City of Torrington

ADDENDUM No. 5

RE: "RECONSTRUCTION OF VARIOUS ROADS PHASE 2020.1"

BID # RVR-027-021320

BITUMINOUS CONCRETE CURB

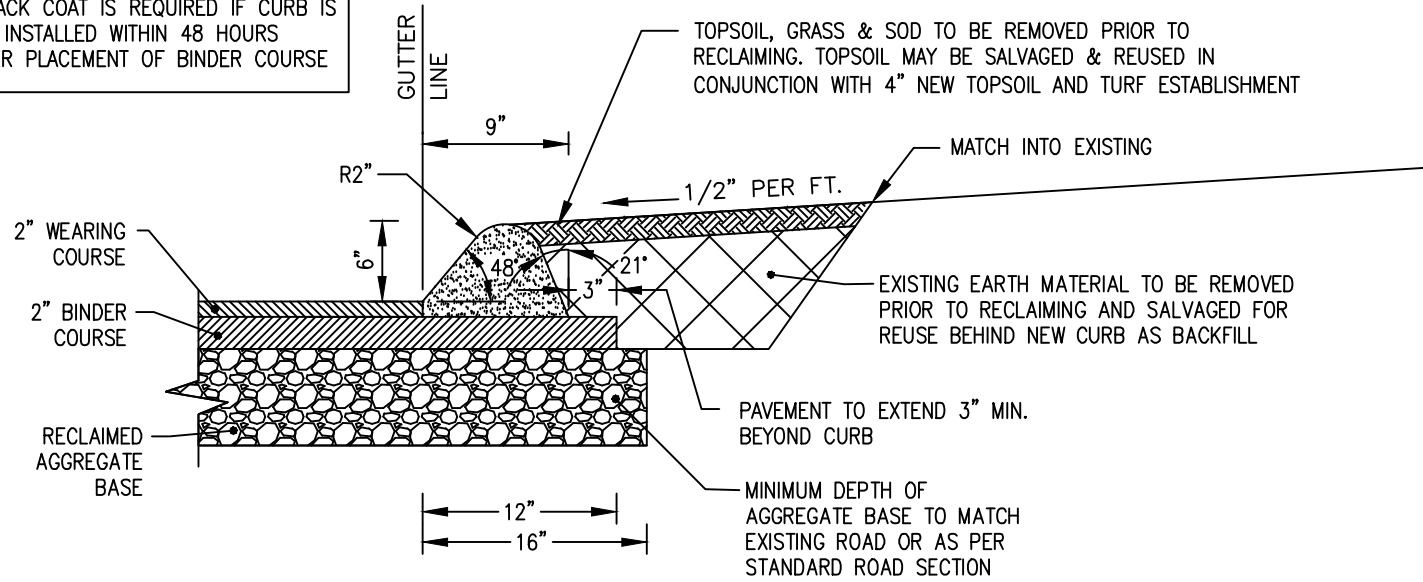
- 2. Add Typical Detail 3.15 "Bituminous Concrete Curb" dated February 14, 2020 (attached) to Drawing Sheet SD-3.**

1. TACK COAT IS REQUIRED IF CURB IS NOT INSTALLED WITHIN 48 HOURS AFTER PLACEMENT OF BINDER COURSE
